Product change notification (PCN)

| Title / short description | PT 2,5 L current bars, change from post-tinning to pre-tinning |
| Change number | CBE200195-0 |

Change Project CBE200195

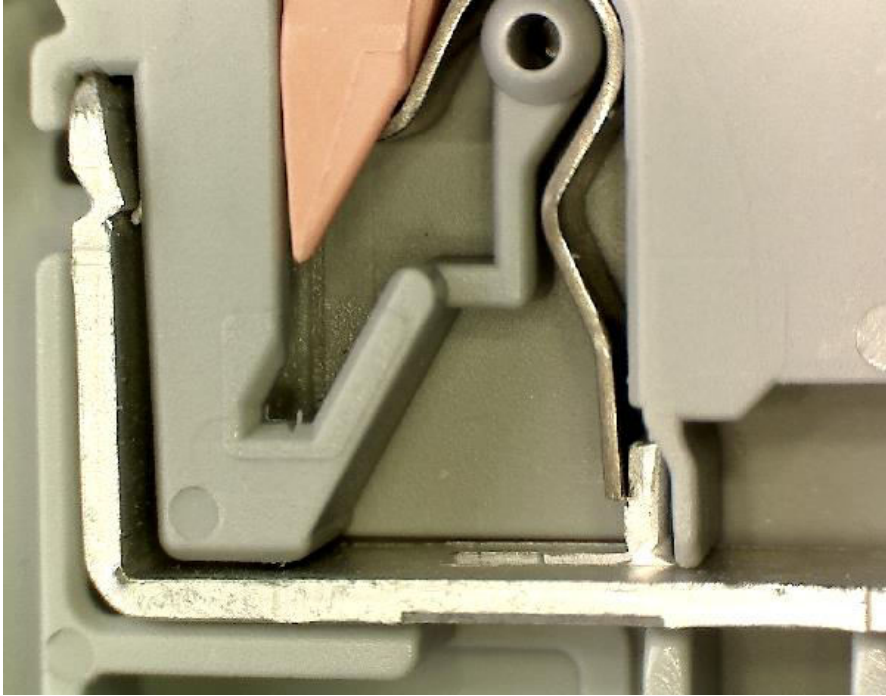
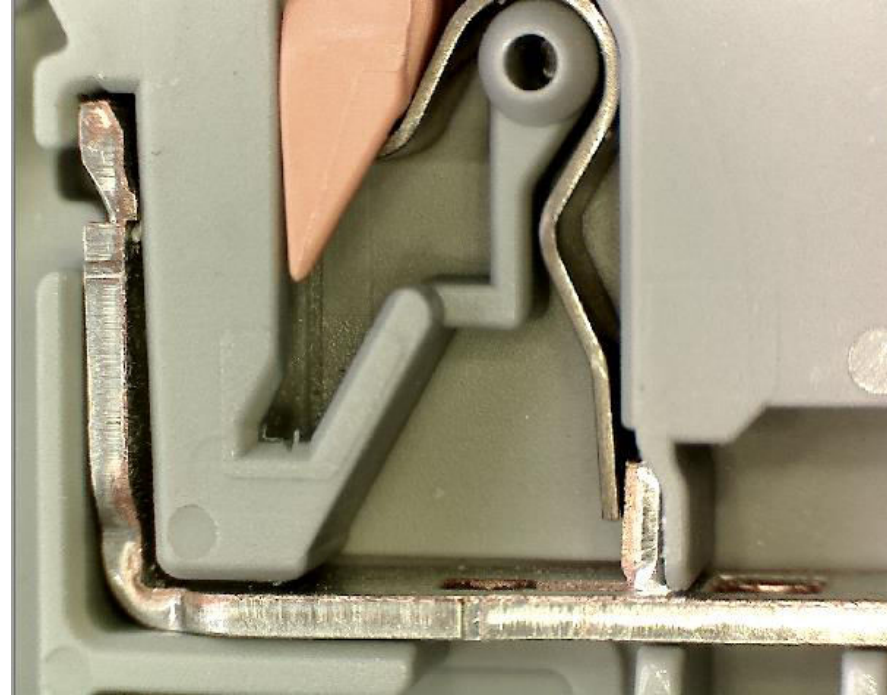
1. The current bar of the PT 2,5 I-shape design terminal block with **pre-plated** tin, the cutted side and therefore copper is visible.
2. The current bar of the PT 2,5 I-shape design terminal block with **post-plated** tin, the cutted side and therefore copper is not visible.

Old V/C post-plated

New V/C pre-plated
